SUBJECT: 007999 – SR99 Bored Tunnel Alternative Design-Build Project
Federal-Aid No. BR-NH-STP-STPF-0099(111)
CO 172 – PCO 575, A.Way Restor-Const

**WASHINGTON STATE
DEPARTMENT OF TRANSPORTATION
CHANGE ORDER**

CONTRACT NO: 007999 FEDERAL AID NO: STP-ER-IM-0099 (11)
 CONTRACT TITLE: SR 99, BORED TUNNEL ALTERNATIVE - DESIGN BUILD PRO
 CHANGE ORDER NO: 172 PCO 575, A.WAY RESTOR-CONST

SR 99 TUNNEL PROJECT CONTRACT PACKAGE 14	S1152
STREET RESTORATION SIGNING PLAN	SHEET OF SHEETS

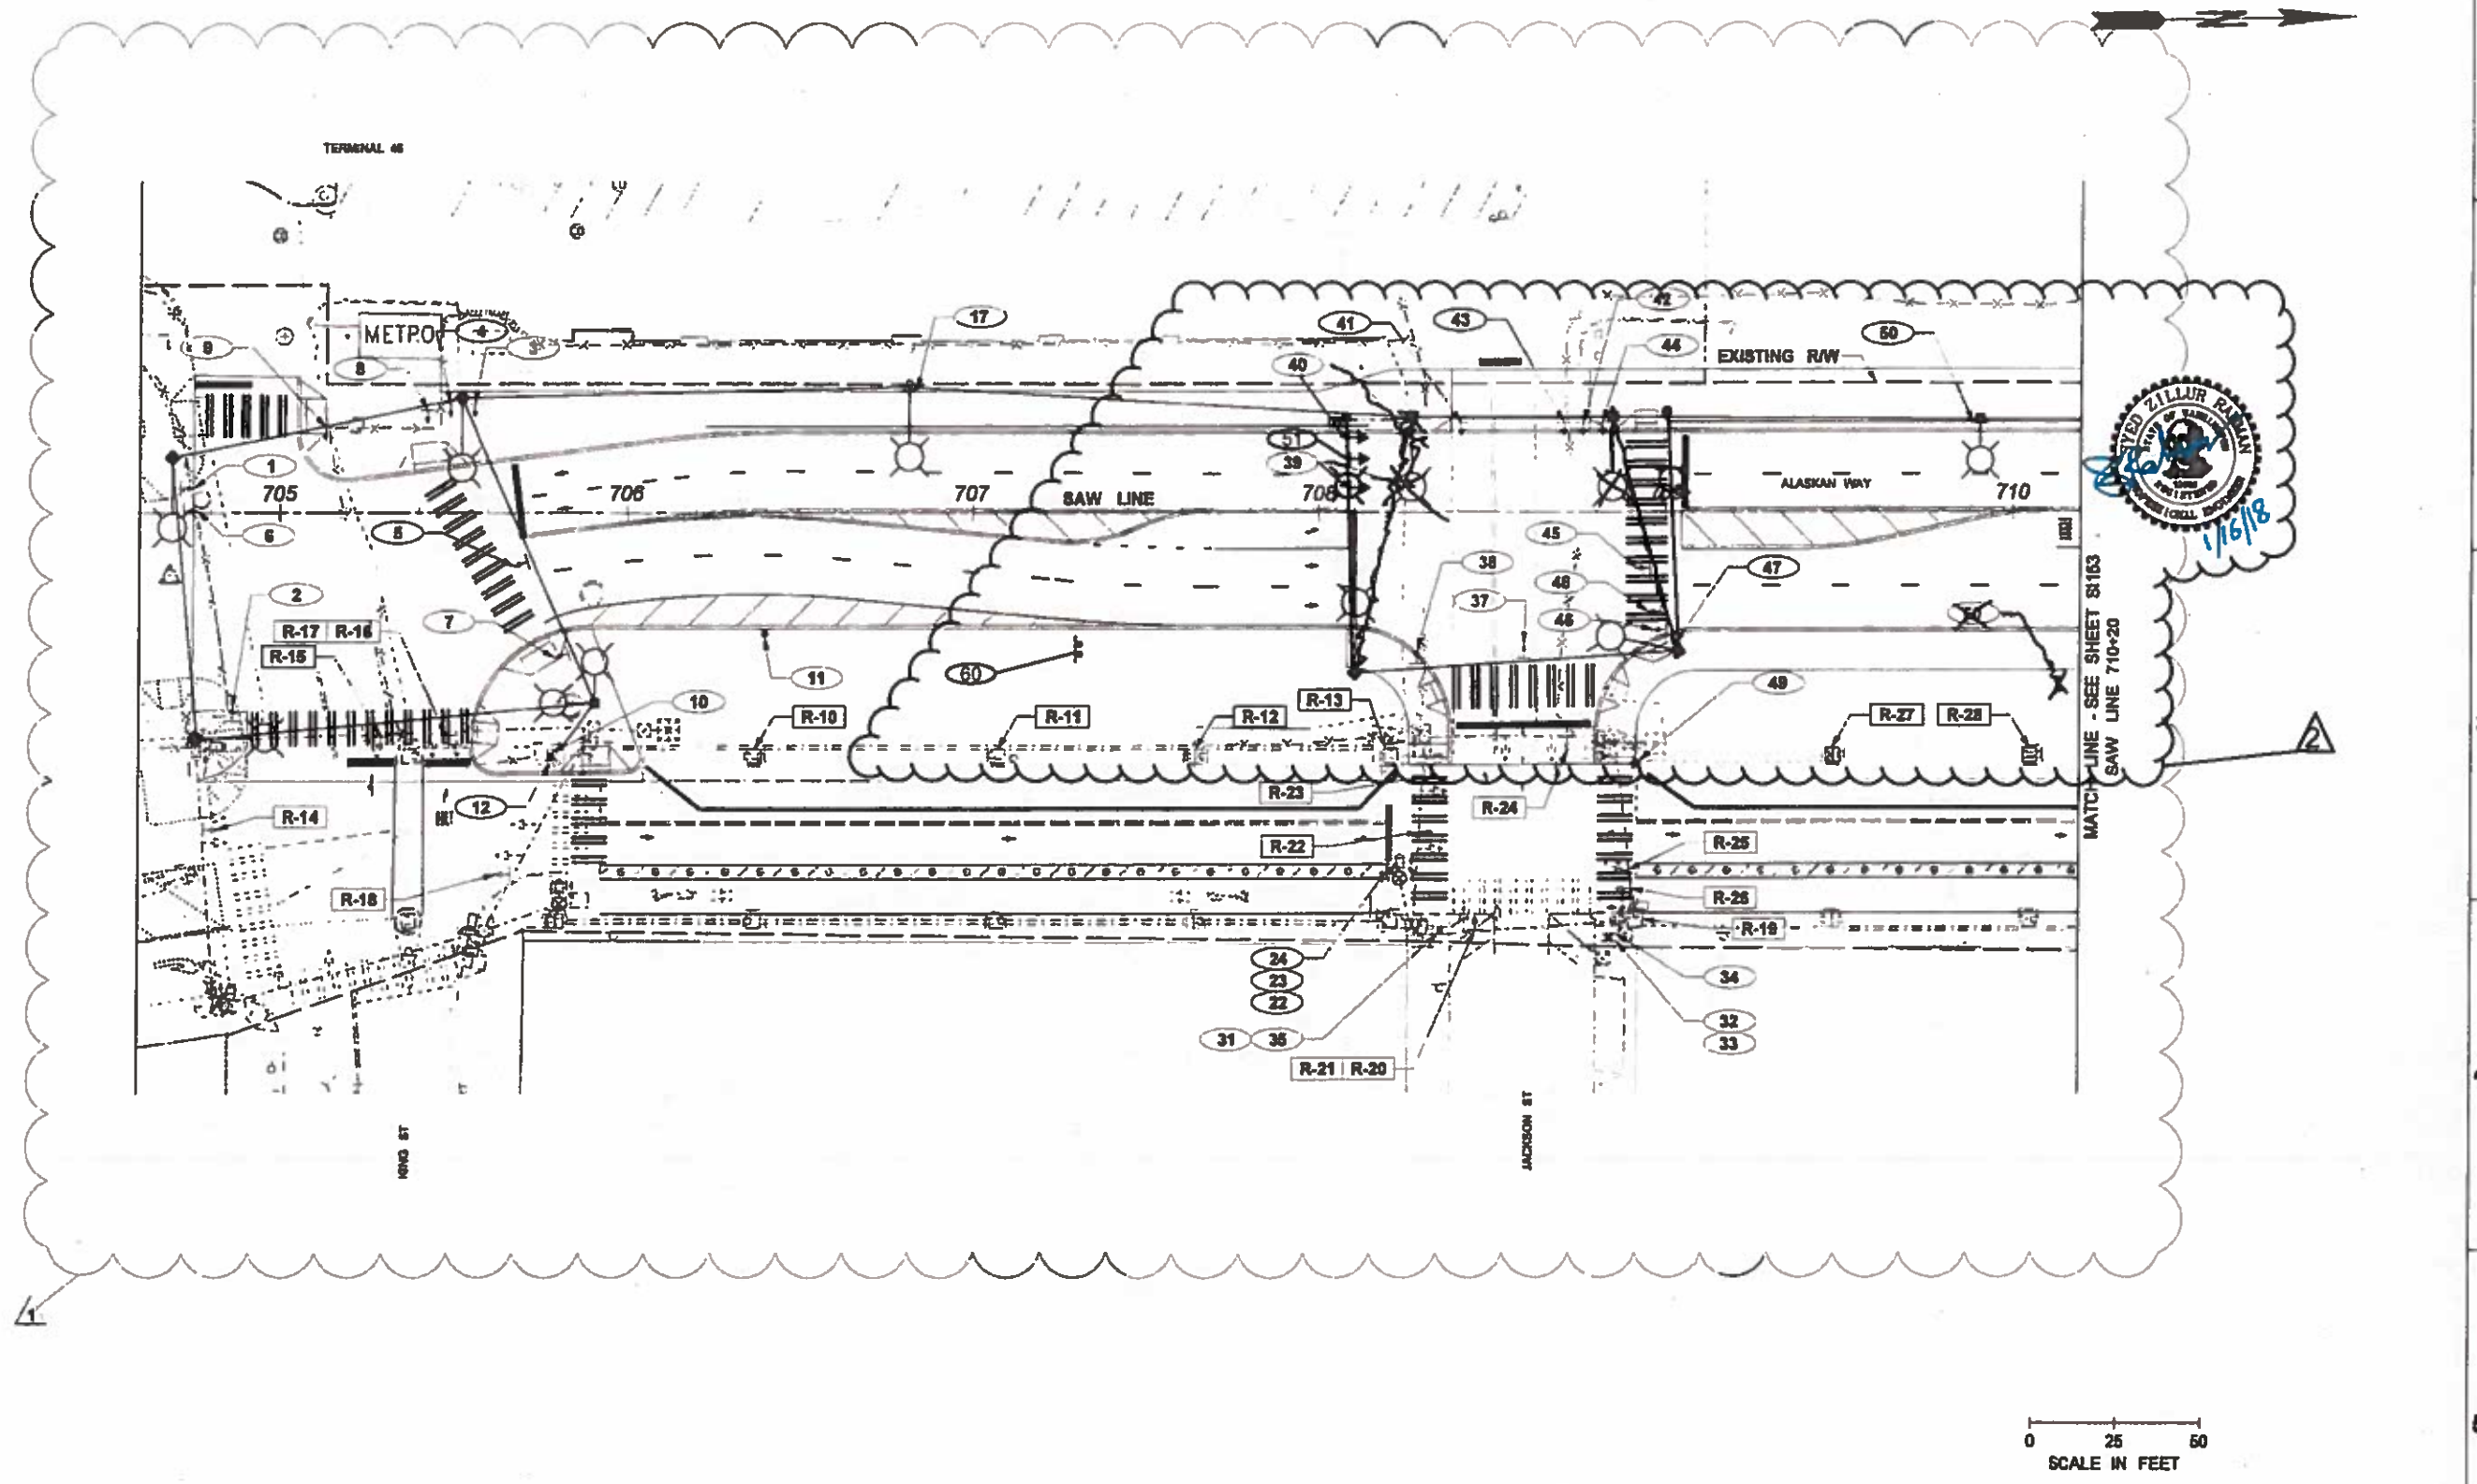
RFI-04147	01/09/2018	SZR
NDC 096 - STREET RESTORATION MODIFICATIONS	06/09/2017	PC
REVISION	DATE	BY
